**1 Products affected**

Product Change Notification					FAC improvement		
owner	creation date	release date	released by	change order no	rev	page	D10-013-731
dislercy	2017-02-09	2017-06-02	nowakfr	2010874	A	1 of 2

**2 Type of change**

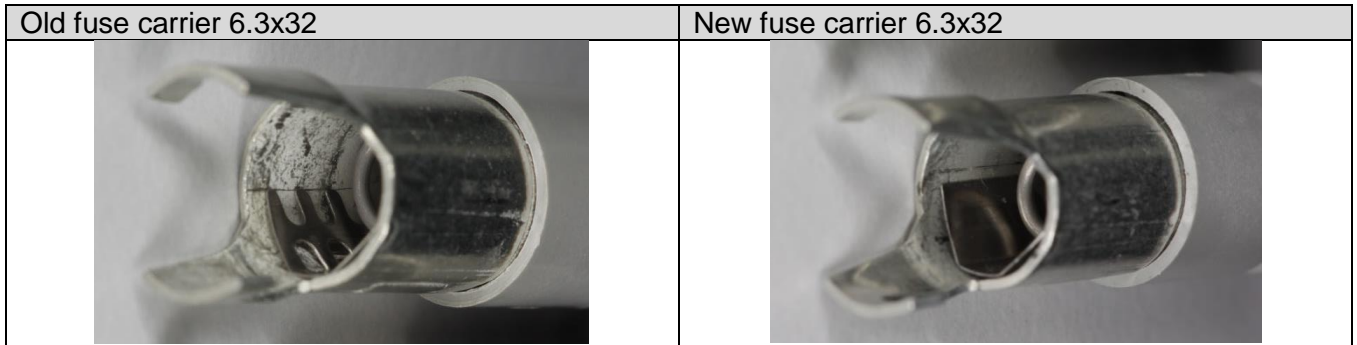
- Change of material
- Modified label
- Change of marking
- Improved voltage rating
- Improved electrical contact
